Product change notification (PCN)

Title / short description	UK 35 mould replacement
Affected article category	Terminal blocks
Change category	Form and appearance
Change number	PBE210263-00
Reason for PCN/PDN Revision

PBE210263

UK 35 N*

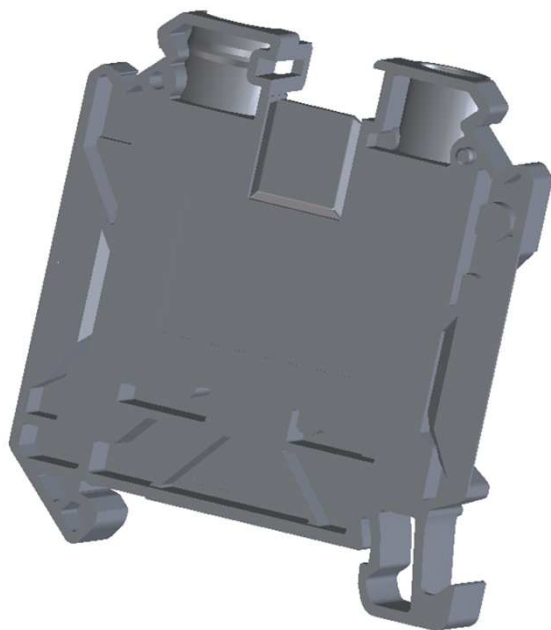
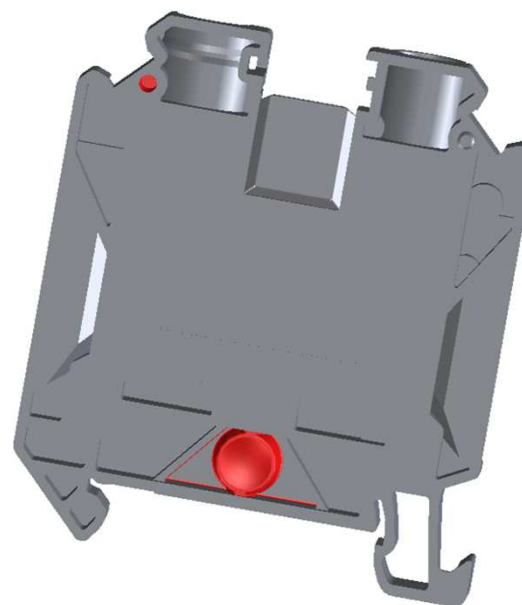
The existing moulding tools will be replaced by new moulding tools. As part of this tool replacement, a process change will be implemented, transitioning from cold runner moulding to hot runner moulding. This change will result in a minor, non-functional visual difference in the form of the addition of an injection point on the products.

- The addition of an injection point
- An updated V/C (Version Change) index

- see marked areas on the pictures

USLKG 35

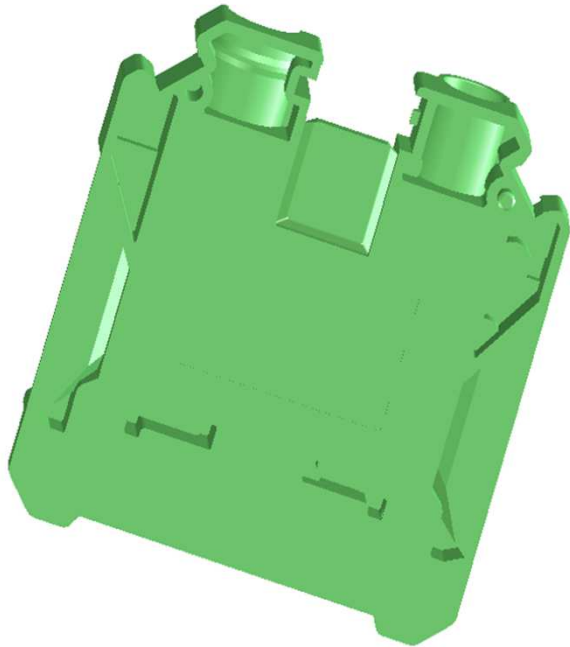
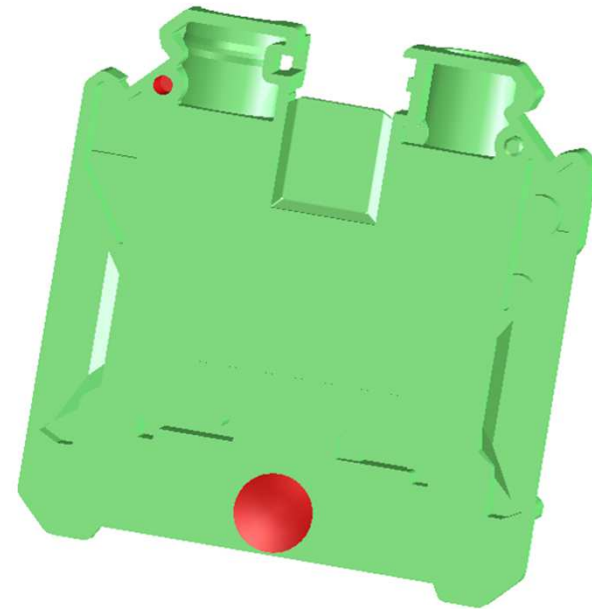
- see marked areas on the pictures
